April 10, 2025

Thank you again for submitting the subdivision application for Hillcamp Drive Filing No. 1; we received this application package on March 21, 2025. The application has been assigned the project number of SB25-0014.

The City has now completed its initial completeness and technical review of the application materials. Below you will find comments from the Planning Division and Public Works Department on the subdivision application materials.

- a. Sheet 4 Keymap:

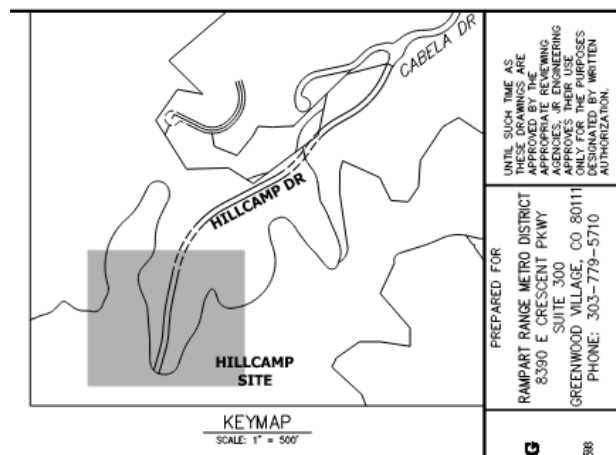
4. General – Temporary re-routes of any trails being impacted by this project must be provided during construction.
5. Existing Conditions and Demolition Plan Sheets (Sheet 4 and Sheet 5) appear to be missing a section of the plat area and street construction limits. The section that is missing is in close proximity to where the proposed street will cross the most significant drainage corridor through the plat area, so further detail on the grading limits and vegetation removal limits in this area is needed. See section not identified in these sheets below:

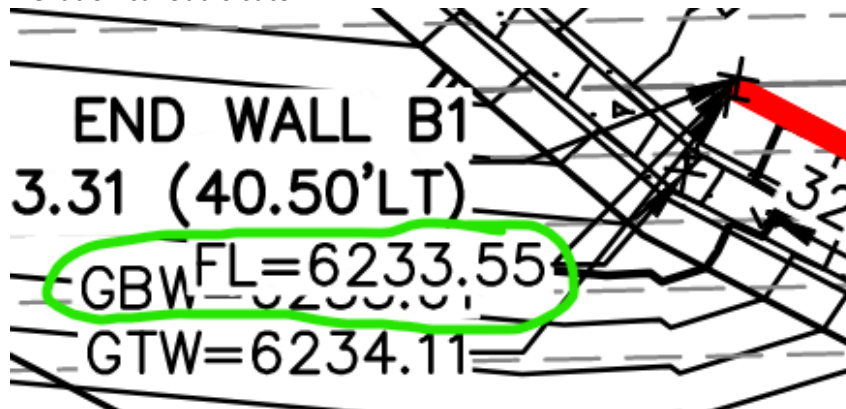
1. The temporary turnaround at the end of the road should be paved and not gravel.
2. As previously stated, please use high-speed mountable curb adjacent to the sidewalk. In the event of an emergency, this will allow for the utilization of the sidewalk to bypass potential obstructions. This is especially relevant since it is looking like this will be the only access road for the subdivision.
3. Add speed limit (30 mph) signage as needed.
4. Sheet 15: please verify end of retaining wall

5. Elevation callout is cutoff

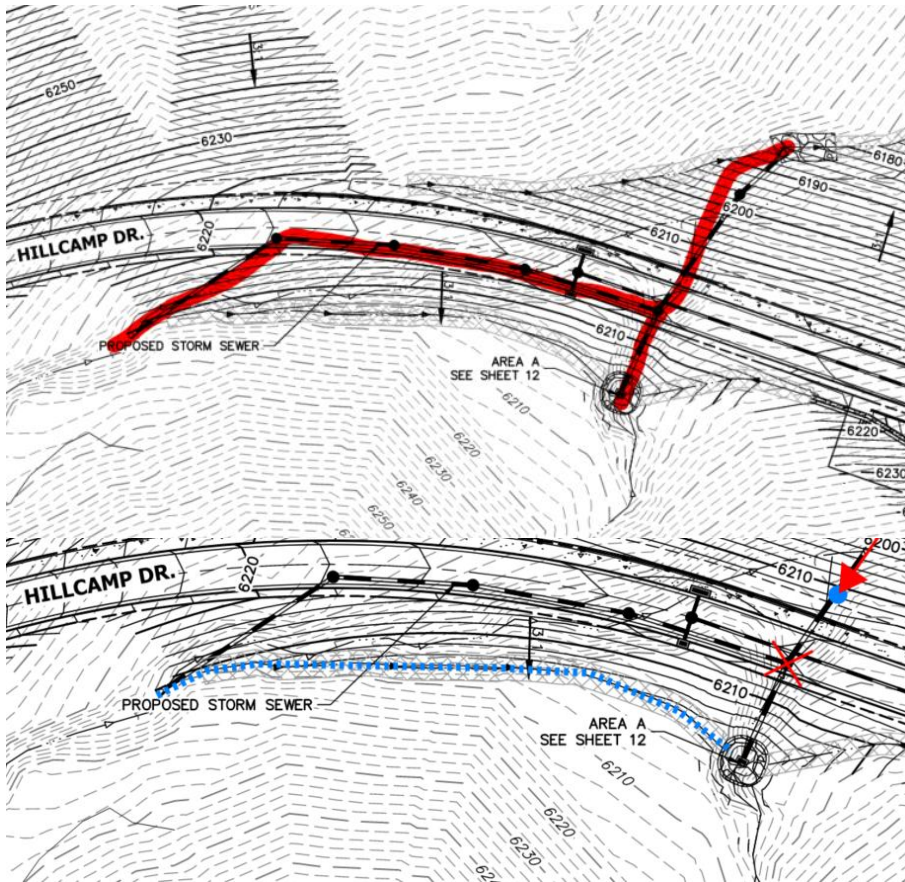
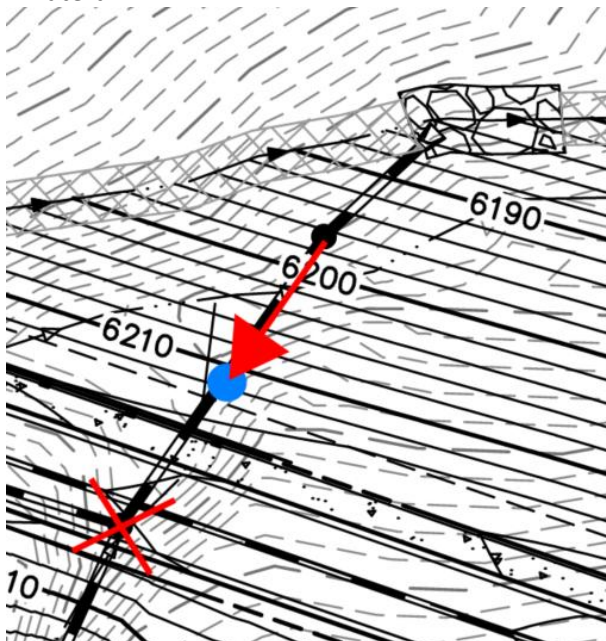
11. Please provide information for intermediate platform at manhole in DP-OS1.1 due to the depth exceeding 20'.
12. Show crossing storm in DP-OS1.1
13. This amount of infrastructure appears to be unnecessary. Some options the city suggests:

- a. Remove the FES and 4 manholes, and just use the swale to route everything to the proposed area inlet.
 - b. Propose another area inlet where the FES is and tie directly into the eastern area inlet.

- c. This will allow to eliminate extra infrastructure within the roadway.

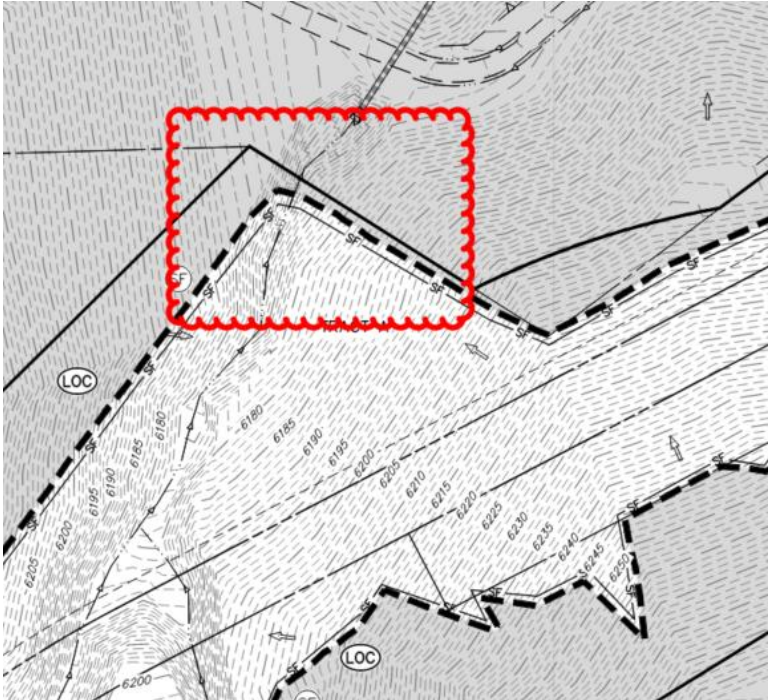
15. Provide a concrete apron on all proposed area inlets

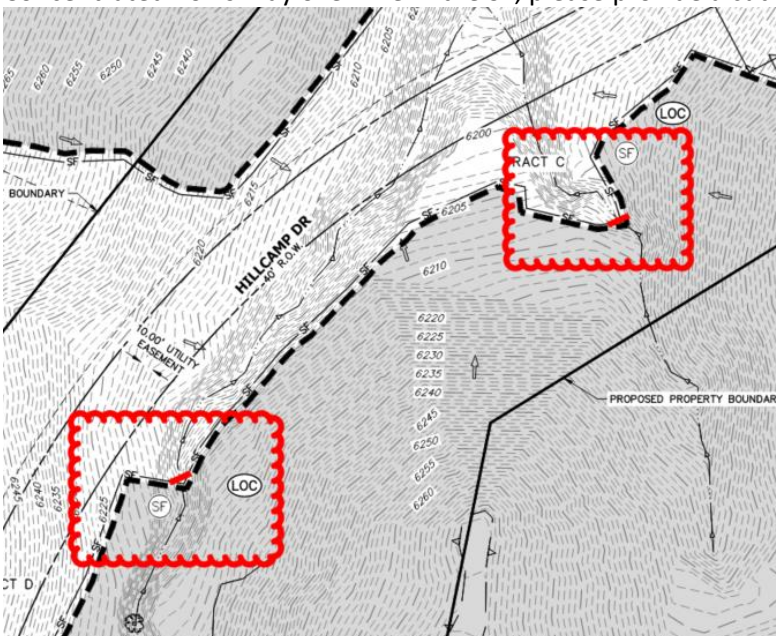
4. Is the trail going to be closed for the duration of the project? If the trail will remain open, how will trail users be rerouted.
5. What is the tributary area to this discharge location? A sediment basin or trap may be necessary. If tributary acreage meets threshold for a basin or trap please provide calculations for the sizing within the GESC report.

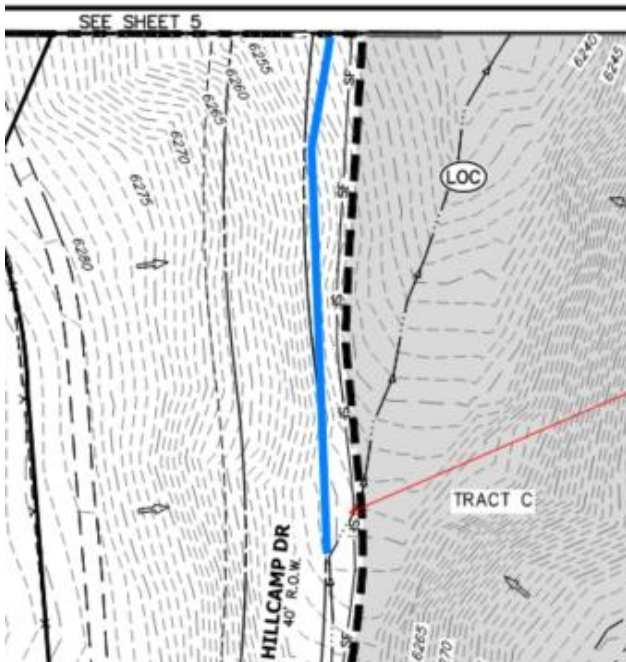
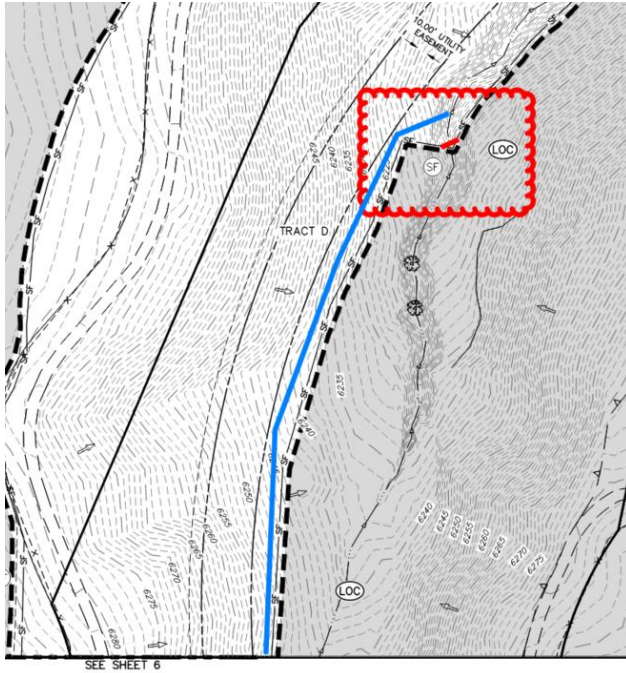
6. Concentrated flows may overwhelm the SF, please provide a cut in the SF and add a Check Dam.

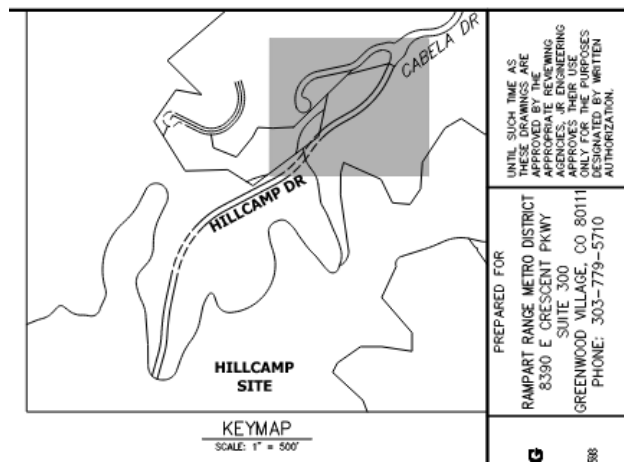
3. General – The proposed pond at the northern end of the project (generally located between the Hillcamp Drive extension and Viewside Drive) is located within a tract outside of the proposed plat boundary on land owned by the Retreat at RidgeGate Homeowners Associate Inc. Verify and provide evidence of this property owner's acceptance of the construction of these improvements on their property. Also, verify future ownership and maintenance responsibilities of these proposed pond improvements.

Applicant Response: Coordination with the Retreat at Ridgegate HOA is ongoing regarding Tract M1. A copy of the letter provided to the HOA is included in the resubmittal, along with an alternative water quality option if it is determined the pond tract will not be conveyed to RRMD for maintenance.

- a. Sheet 4 Keymap:

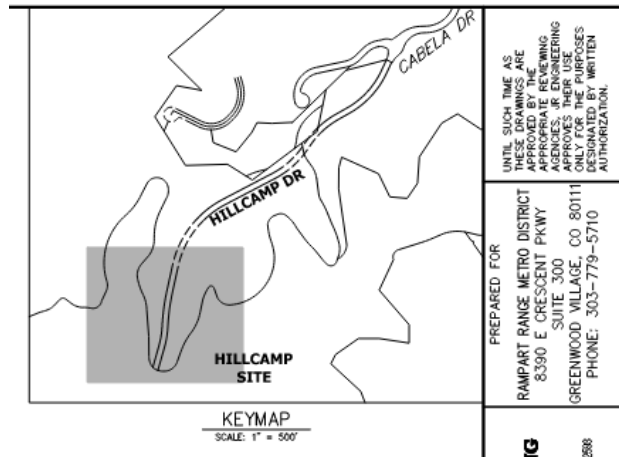
5. Existing Conditions and Demolition Plan Sheets (Sheet 4 and Sheet 5) appear to be missing a section of the plat area and street construction limits. The section that is missing is in close proximity to where the proposed street will cross the most significant drainage corridor through the plat area, so further detail on the grading limits and vegetation removal limits in this area is needed. See section not identified in these sheets below:

Applicant Response: Sheet has been added showing the missing area.

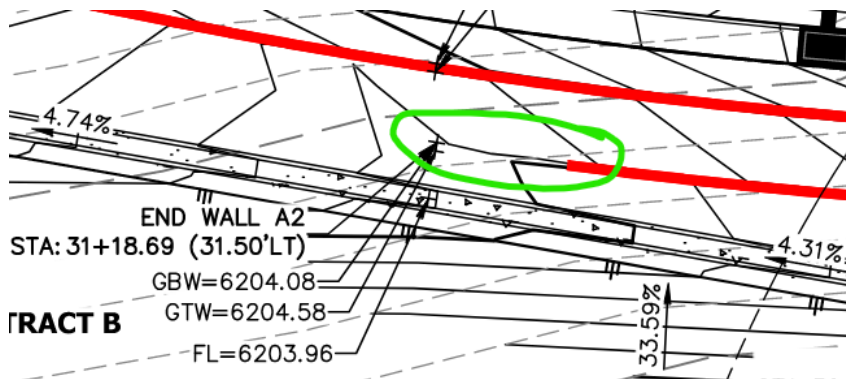
2. As previously stated, please use high-speed mountable curb adjacent to the sidewalk. In the event of an emergency, this will allow for the utilization of the sidewalk to bypass potential obstructions. This is especially relevant since it is looking like this will be the only access road for the subdivision.

Applicant Response: High-speed mountable curb has been added to the design.

4. Sheet 15: please verify end of retaining wall

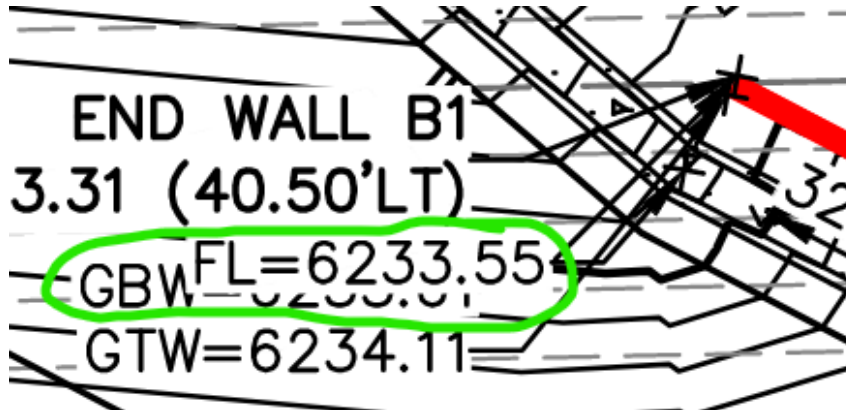
5. Elevation callout is cutoff

Applicant Response: Retaining wall has been updated.

Applicant Response: Labels have been moved as needed.

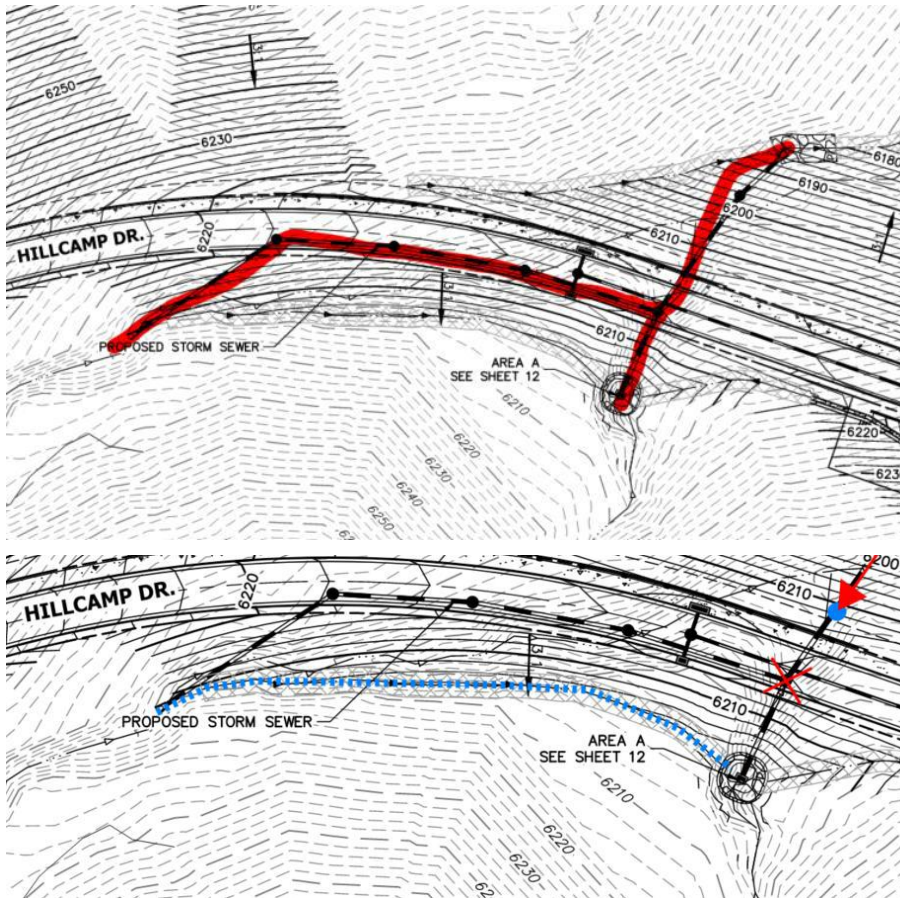
- a. Tie proposed storm directly into the downstream existing Type D inlet.
- b. Provide a concrete apron on the existing Type D inlet and have the FES discharge directly onto the apron.

Applicant Response: The Type D inlet is located offsite and outside of the boundary of the improvements. A low tailwater basin has been added at the end of the FES to dissipate energy and flows from the FES which will then be conveyed down the hill consistent with the existing condition into the Type D inlet.

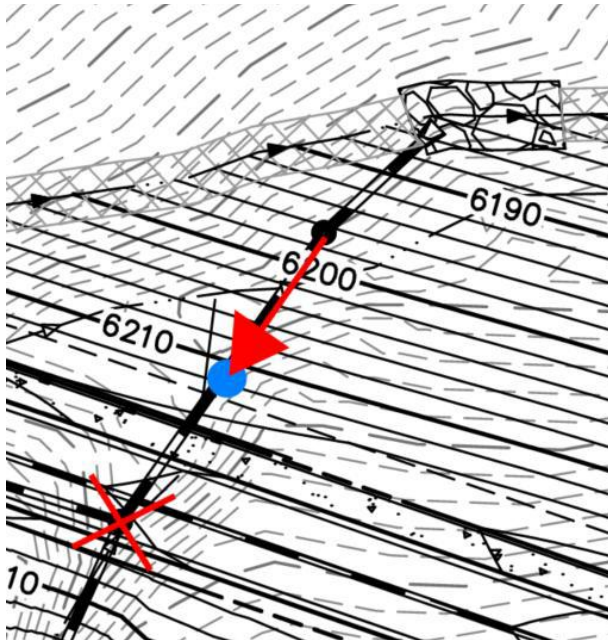
13. This amount of infrastructure appears to be unnecessary. Some options the city suggests:
- a. Remove the FES and 4 manholes, and just use the swale to route everything to be proposed area inlet.
 - b. Propose another area inlet where the FES is and tie directly into the eastern area inlet.
 - c. This will allow to eliminate extra infrastructure within the roadway.

Applicant Response: Swale has been regraded to convey flows to the eastern area inlet and FES and infrastructure in the road has been removed.

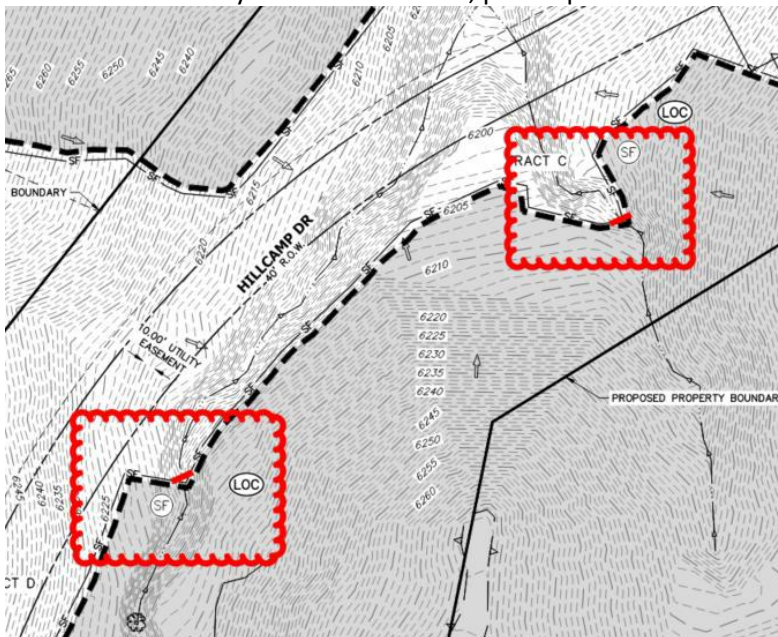
4. Is the trail going to be closed for the duration of the project? If the trail will remain open, how will trail users be rerouted.

Applicant Response: The east-west trail will remain open throughout the project. The temporary trail reroute has been called out on the interim plans.

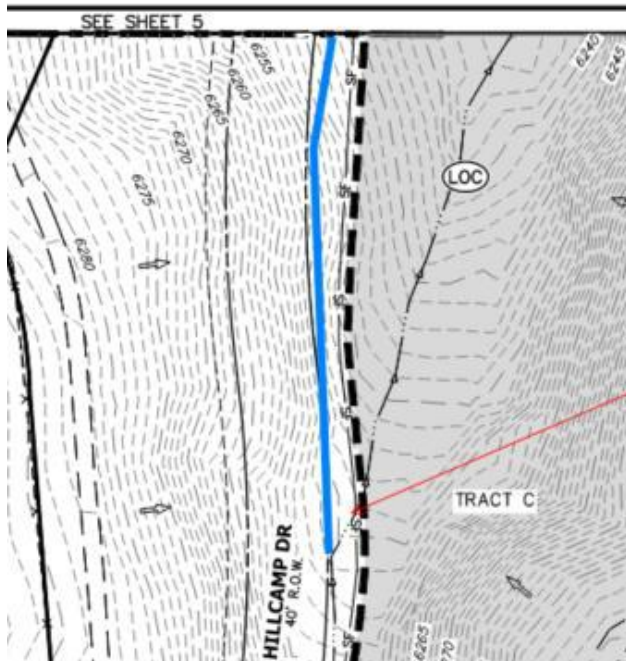
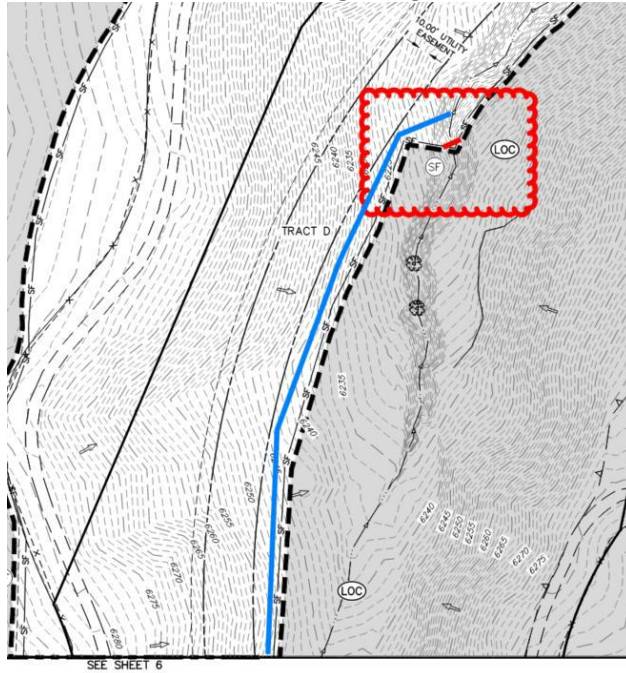
6. Concentrated flows may overwhelm the SF, please provide a cut in the SF and add a Check Dam.

Applicant Response: Check dams have been added in lieu of silt fence at these locations.

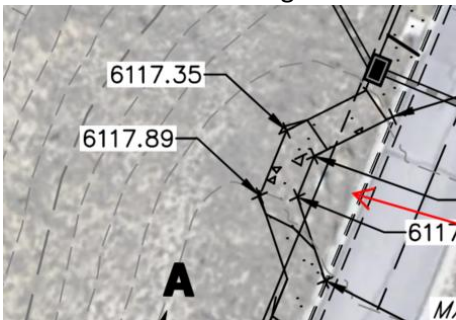
8. Call out TRM lining extents and quantity and reference detail
9. Call out and specify riprap at DP-A1 FES per drainage report calculations

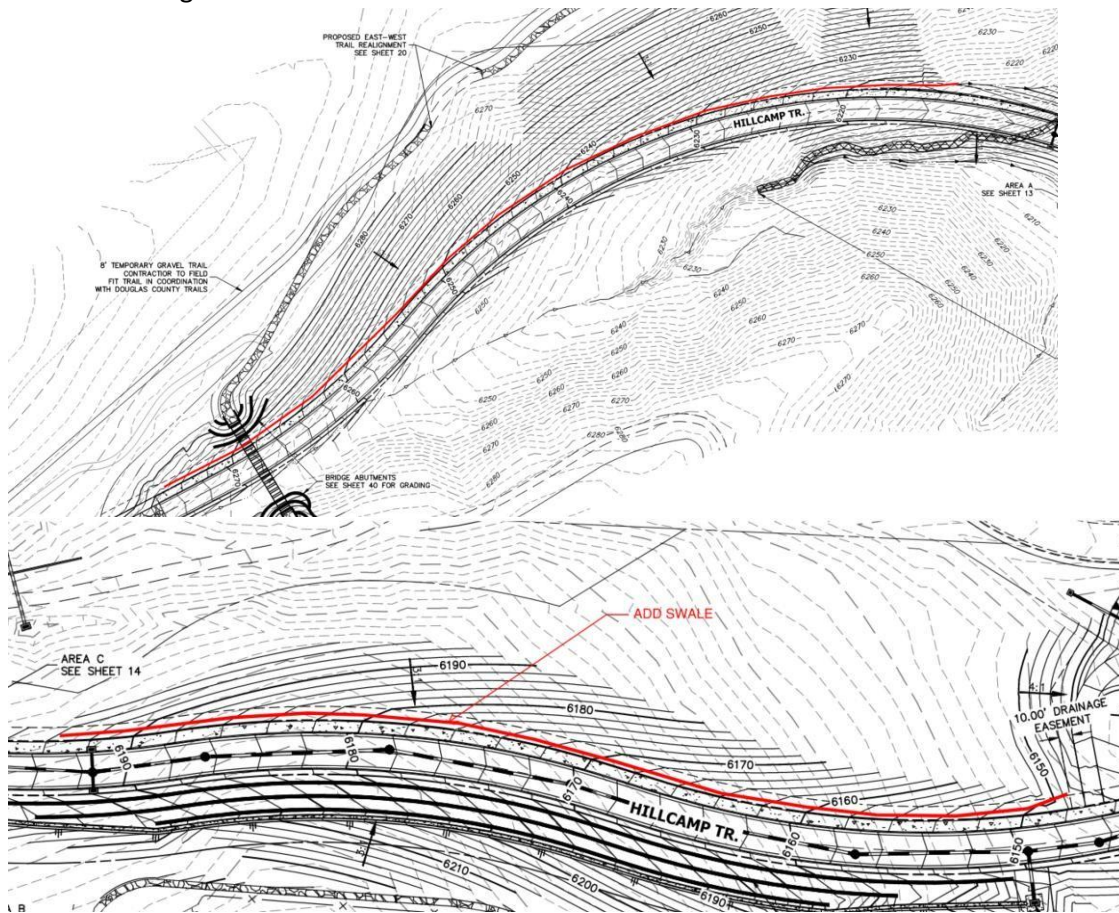
4. Although the pond retrofit has capacity for the 500-year storm event, a dedicated emergency spillway is necessary in the event of clogging or a larger storm event. Please also include details on the spillway with the other detention pond details.

Applicant Response: The pond is no longer proposed.

14. Sheet 38:

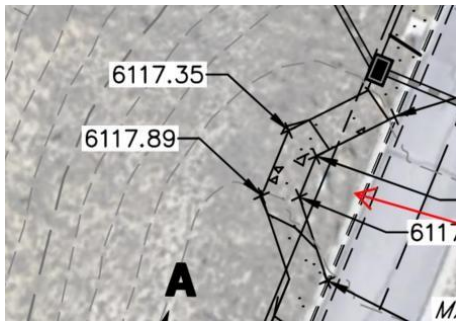
- a. Text has been cut off for the Outlet Structure Profile View at left viewport.
- b. Section A-A calls out the plate at 6" above the 18" invert, however, the drainage design spreadsheet calls out 18" above invert, please verify and update as needed.
- c. Section B-B calls out 15/16" diameter holes, however, the drainage design spreadsheet uses 7/8". Please verify and update as needed.

Applicant Response: The pond is no longer proposed.
